ECE/TRANS/WP.11/2007/11
13 August 2007

Working Party on the Transport of Perishable Foodstuffs

PROPOSALS OF AMENDMENTS TO THE ATP

Paragraph 2 of Article 3

Map of the Baltic Sea

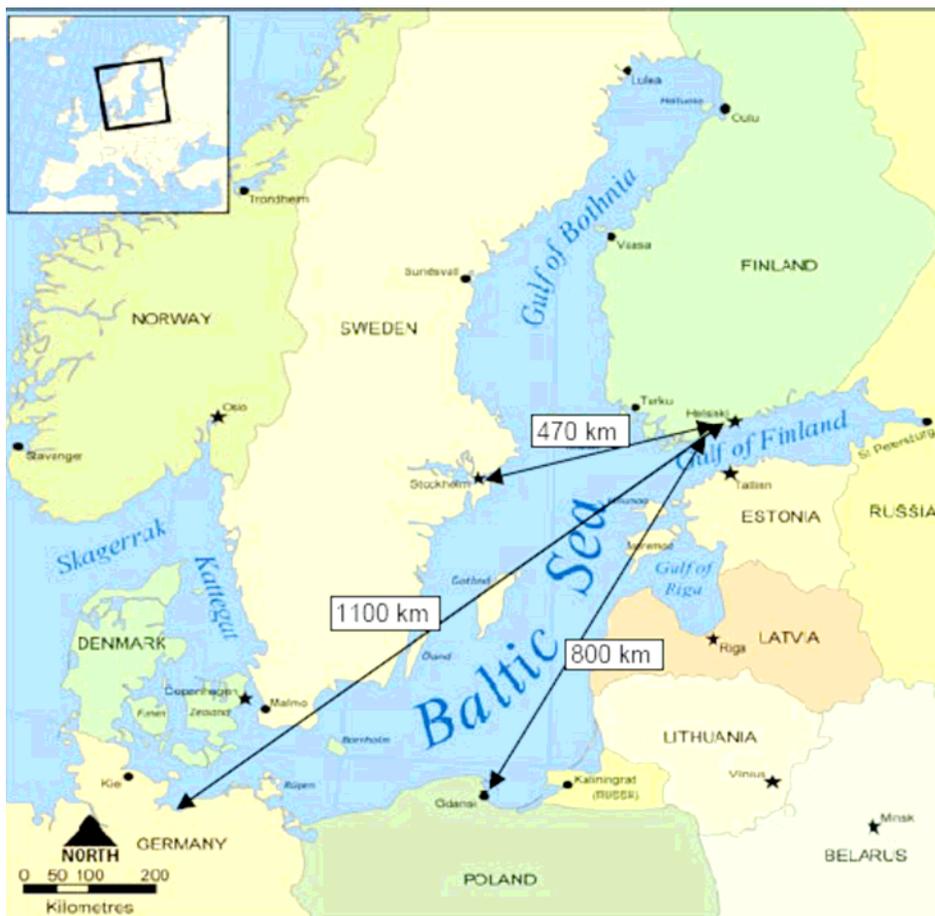
In previous meetings, the representatives of Finland have discussed with representatives of many other countries about the length of the sea crossing referred to in paragraph 2 of Article 3 of the ATP for goods that are shipped in equipment used for the land journey. While sea crossings in the Baltic Sea often exceed 150 km, as between Finland and Germany, Finland and Sweden, Finland and Poland, it is possible to use ATP vehicles, which are not ATP-classified (please see map below).

Length of sea crossings between Finland and Germany (approx. 1100 km), Finland and Poland (approx. 800 km), Finland and Sweden (approx. 470 km).

"2. The provisions of paragraph 1 of this article shall likewise apply to sea crossings of less than **1500** km on condition that the goods are shipped in equipment used for the land journey or journeys without transloading of the goods and that such crossings precede or follow one or more land journeys as referred to in paragraph 1 of this article or take place between two such land journeys."
